**RE: Administrative Amendment- 8001 Wyoming Blvd NE
Planning case file# Z-98-110 / Paseo Village**

The applicant for the above referenced property, JP Morgan Chase Bank, is requesting an administrative amendment to the approved Paseo Village Site Development Plan for Building permit. The intent of the applicant is to convert and renovate the existing 4,937 S.F. restaurant space in “building A” into a financial banking center within the Paseo Village shopping center site. As part of the scope of renovations, the applicant is proposing minor changes to the exterior street-facing façades. In February 2021, Chase Bank’s civil engineers submitted a PRT meeting application for the use of the existing building for a bank and the related improvements. On March 1, 2021 the PRT planning staff reviewed the application and determined that the exterior façade changes and relocation of one of the entry doors would qualify for review under Site Plan- Administrative- and would need to comply with Building Safety regulations and any exterior revisions would be subject to §14-16-5-11(E)(2)(b) Activity Centers. See attached PRT notes. However, after submittal of a building permit for interior renov

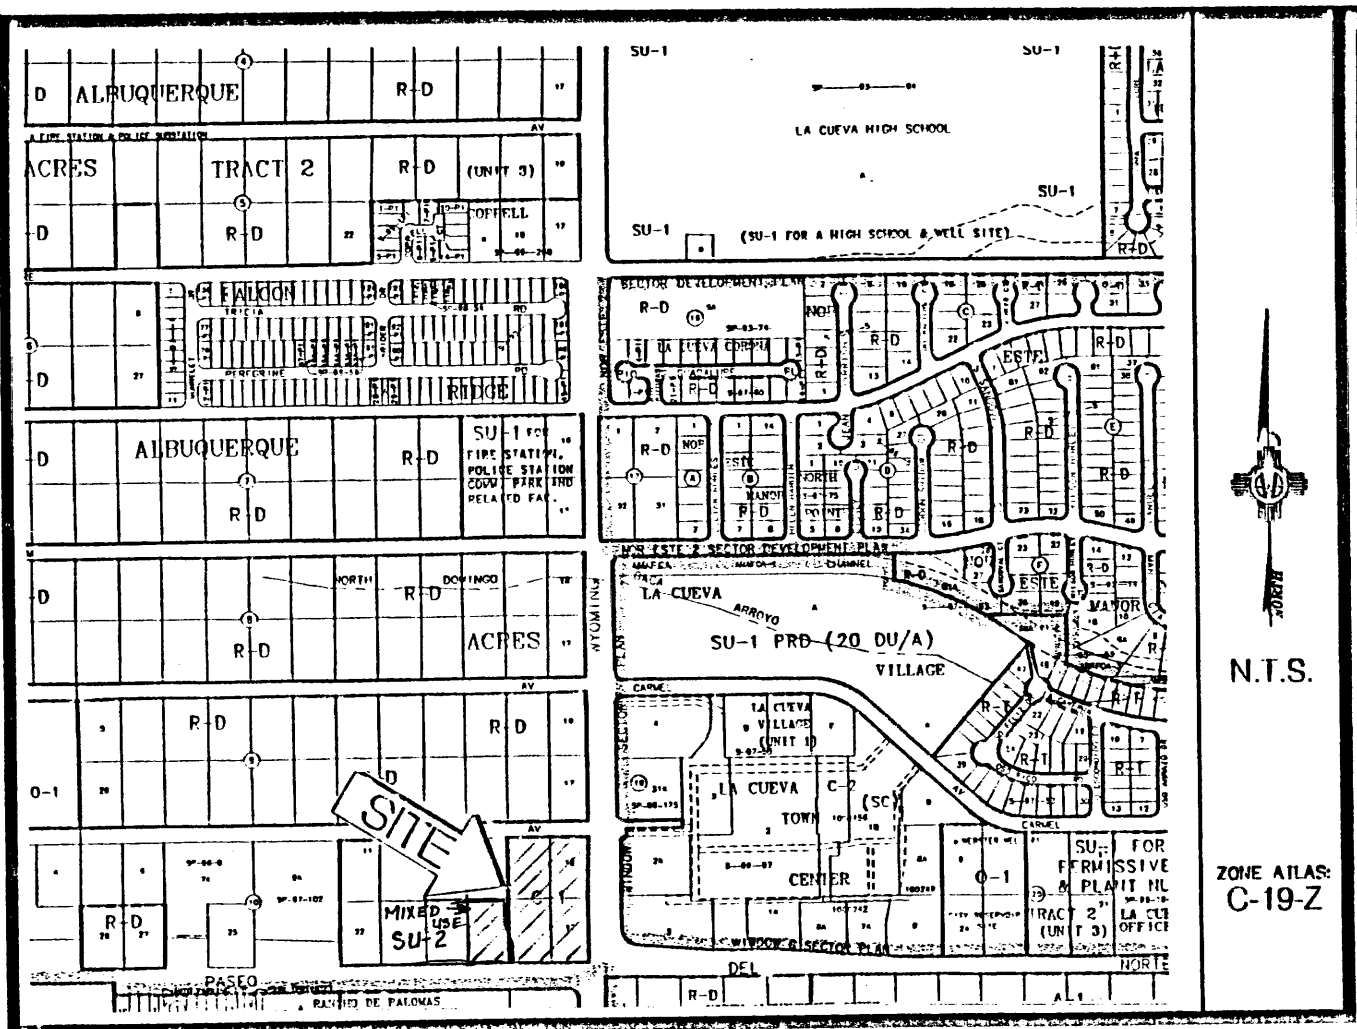
1) Northwest façade- The installation of a fully-glazed storefront and elimination/relocation of one of the three existing doors to the northeast façade

2) Northeast façade- The installation of a fully-glazed storefront with new glass entry/exit door.

The requested changes to the areas of the northeast and northwest facades are circled and noted on the originally approved building elevations for “building A” of the Paseo Village shopping center. Overall, we believe that the proposed changes to the façades are in harmony and consistent with the originally approved Site Development Plan for Building Permit but will also further compliance with the newer regulations of the IDO for glazing requirements of street facing façades. The proposed removal of the existing lower sections of brick veneer and lowering the window sills to allow the installation of a new fully-glazed storefront extending to finished floor level will provide an increase in the percentage of façade glazing and will provide 100% glazing in the deleted brick veneer areas. Although the existing building façades were approved prior to the adoption of the IDO, these minor changes will help incorporate and further achieve the Façade Design requirements of §14-16-5-11(E)(2)(b) of the IDO for new building design within designated Activity Centers. For your review, attached to this application are the architectural elevations that show the proposed new façades with the glazed storefronts in place on the northeast and northwest sides of the building.
